CLIENT:
NORTHWEST KIDNEY CENTERS

PROJECT NAME:
RAINIER BEACH CLINIC

8.0 | EDG RESPONSE

ITEM BY ITEM RESPONSE [8.3]

7.0 | COMPOSITE SITE PLAN

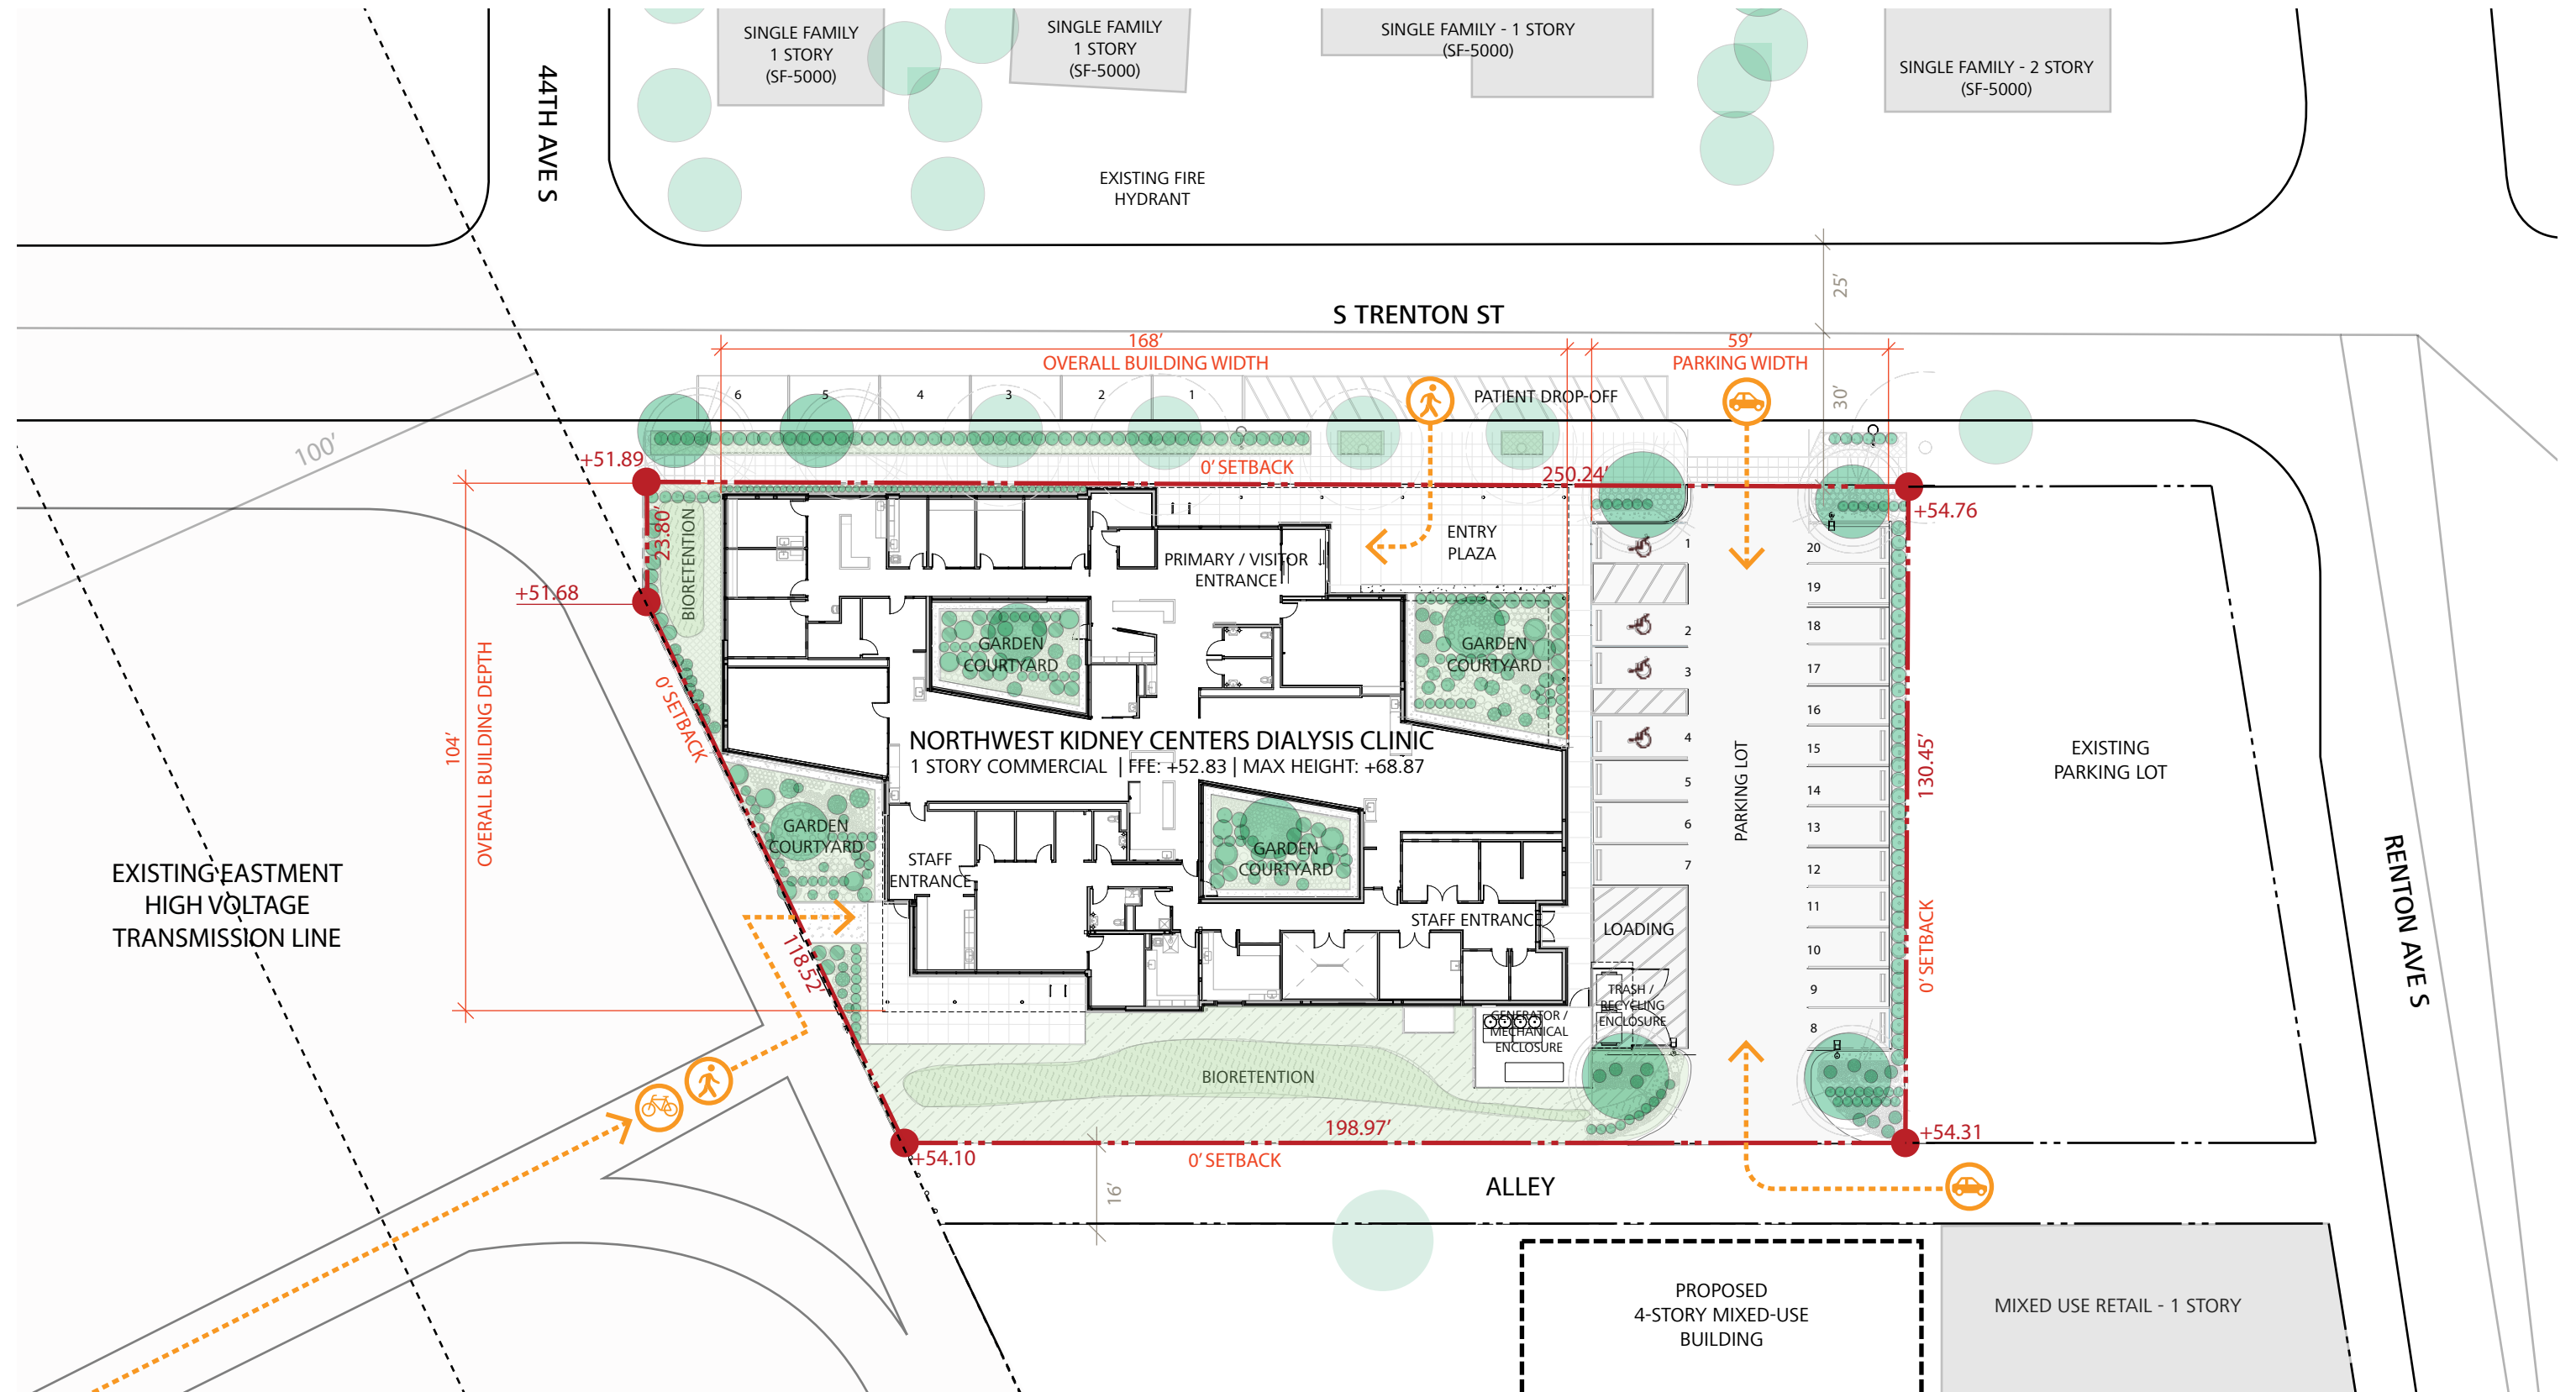
COMMENT 2.A (ACCESS):

The Board acknowledged SDOT's recommendation to eliminate the existing vehicle curb cut along S. Trenton Street and require all off-street parking via the alley on the project's south boundary. However, the Board agreed that a curb cut on S. Trenton Street should be permitted and supported the proposed curb cut location and associated parking lot shown in Concept C. The Board supported the curb cut noting that:

- A curb cut will provide alternative entering and exiting from the site instead of funneling all vehicle and delivery traffic down the alley;
- The alley width is currently undersized for commercial uses;
- The mobility of many clients of the future clinic is limited and an easily identifiable and accessible off-street parking lot from S. Trenton Street would better accommodate the clinic's clients. (DC1-B, PL4-A)

Response: The team has proceeded the inclusion of the curb cut at the northeast end of the site along S. Trenton Street in accordance with the Design Board's recommendations, allowing for clear wayfinding for patients and visitors. Access to the parking lot is also provided to the alley which will allow an alternative entrance/exit for service vehicles and delivery traffic. See Section 7.0 Composite Site Plan for layout.

FIGURE 1.A [17.2]

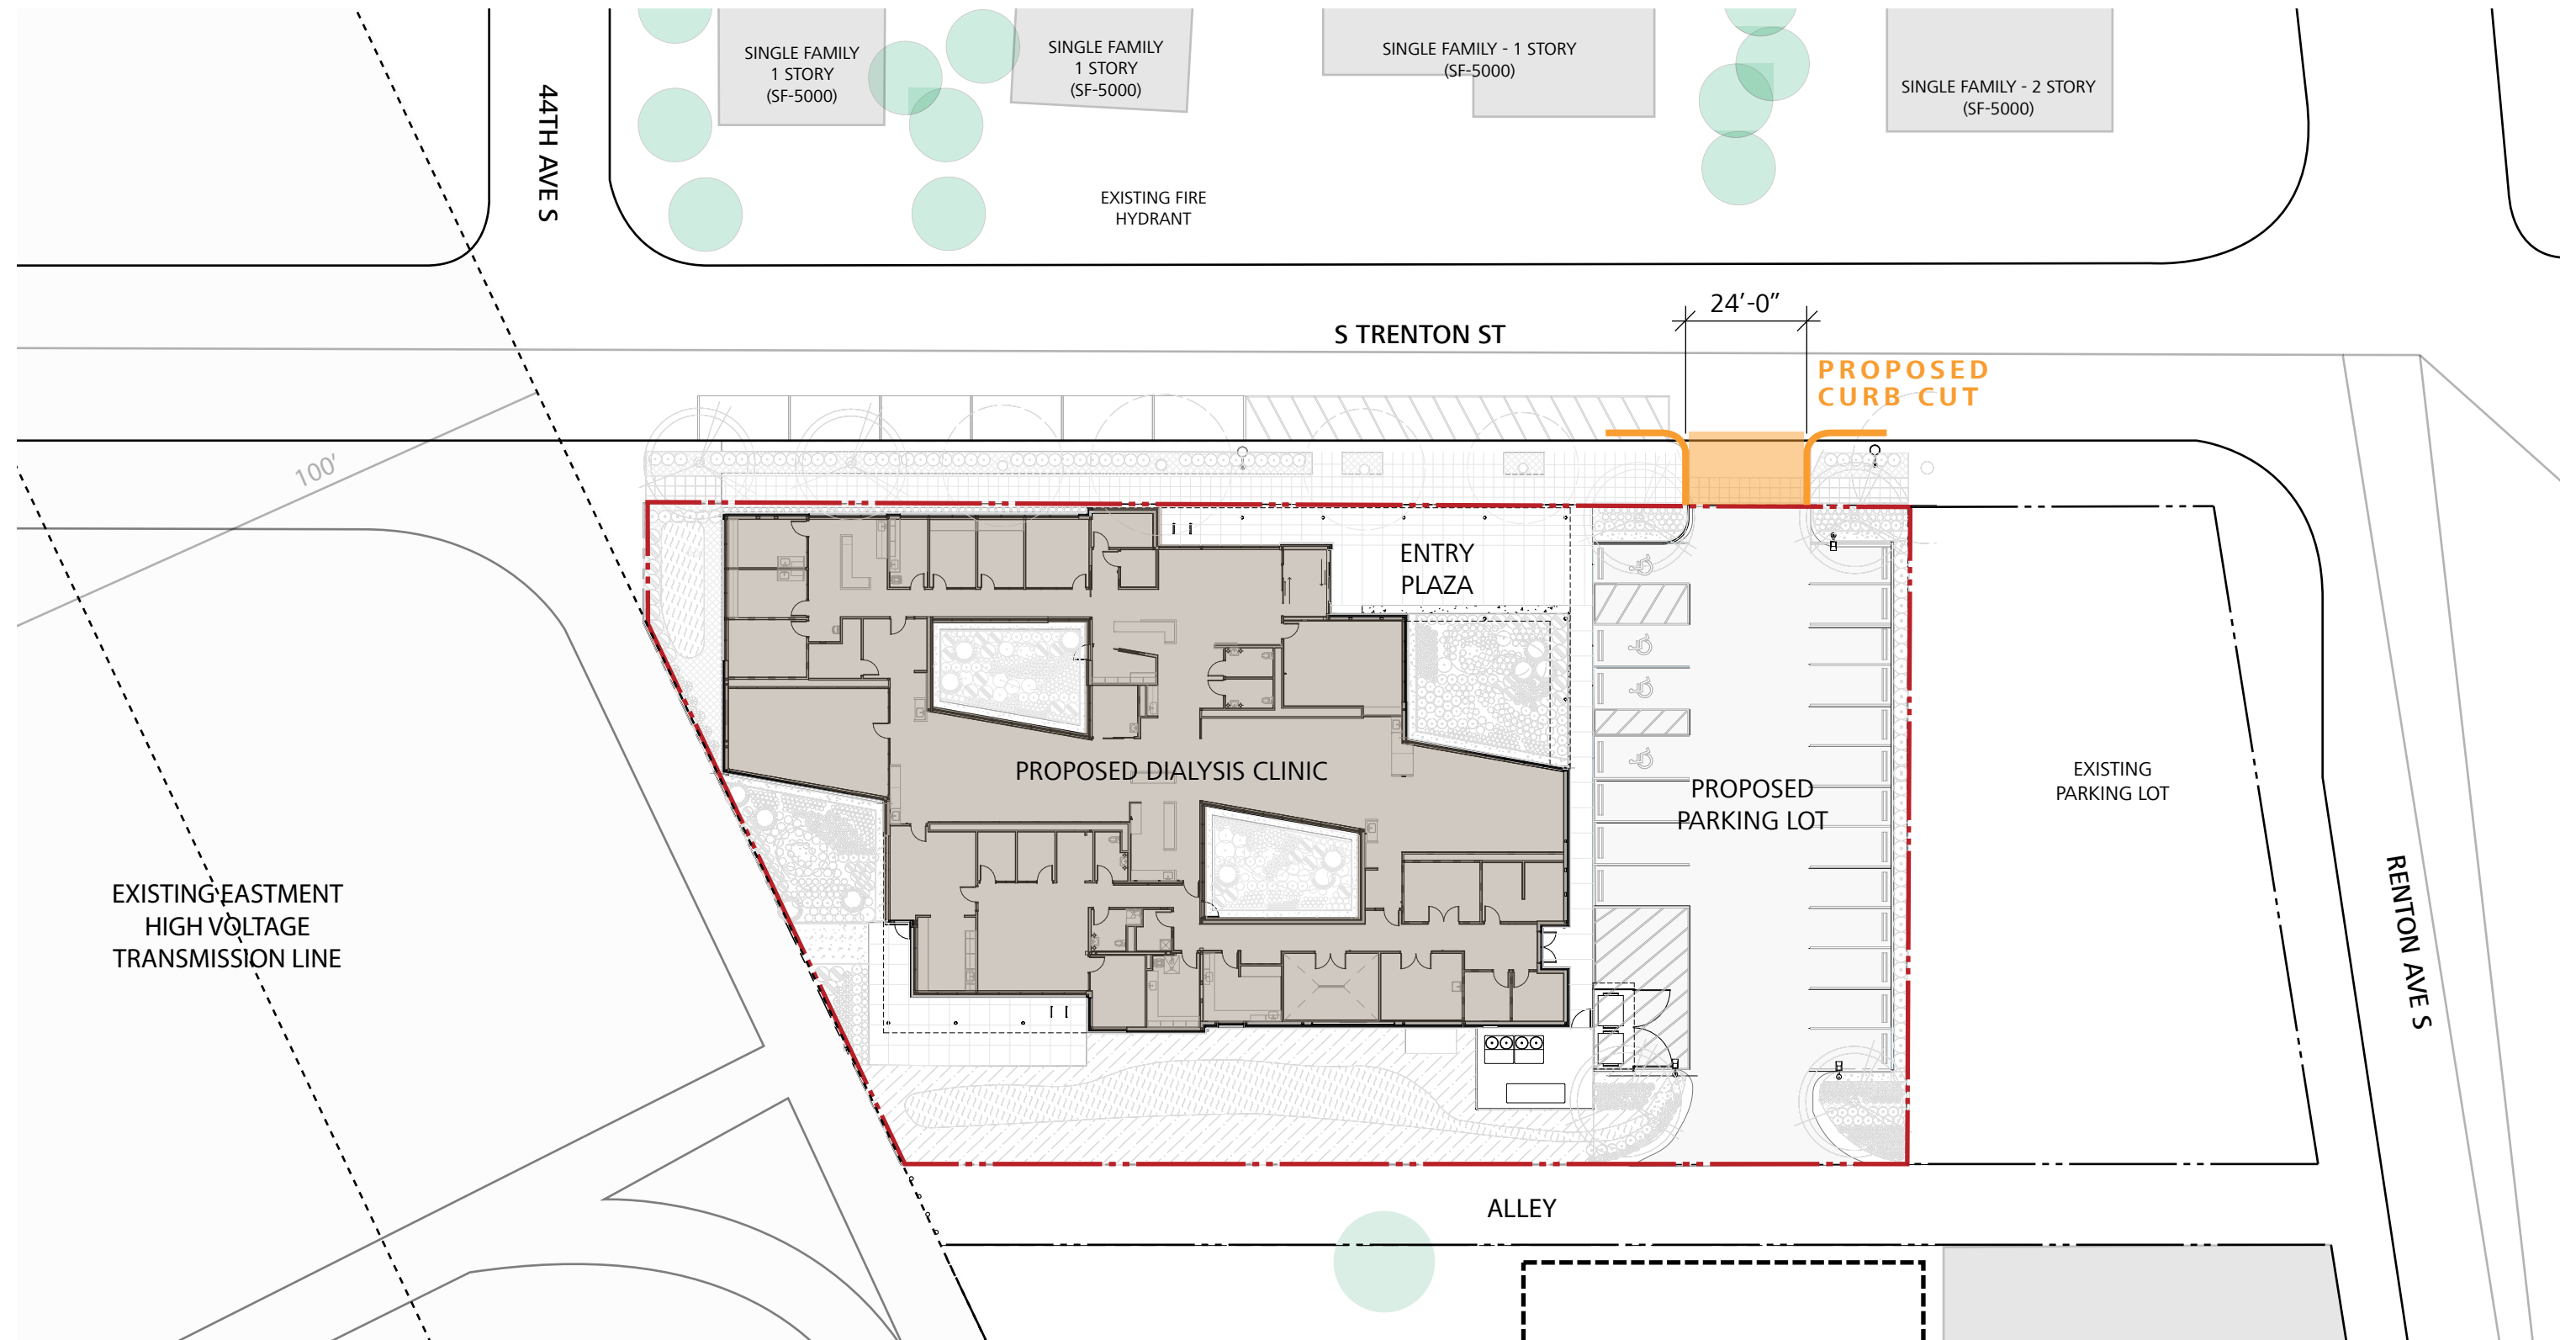
DEPARTURE REQUEST 1: CURB CUT OFF OF S. TRENTON STREET

The project requests a curb cut off of S. Trenton Street as the primary access point to the site parking. This access would be in addition to required alley improvements to allow access to parking from the alley.

The concerns noted above show the safety hazard of only having parking access off of the alley. Due to the unique aspect of the existing alley being a dead end, allowing the curb cut off of S. Trenton Street will better serve the community.
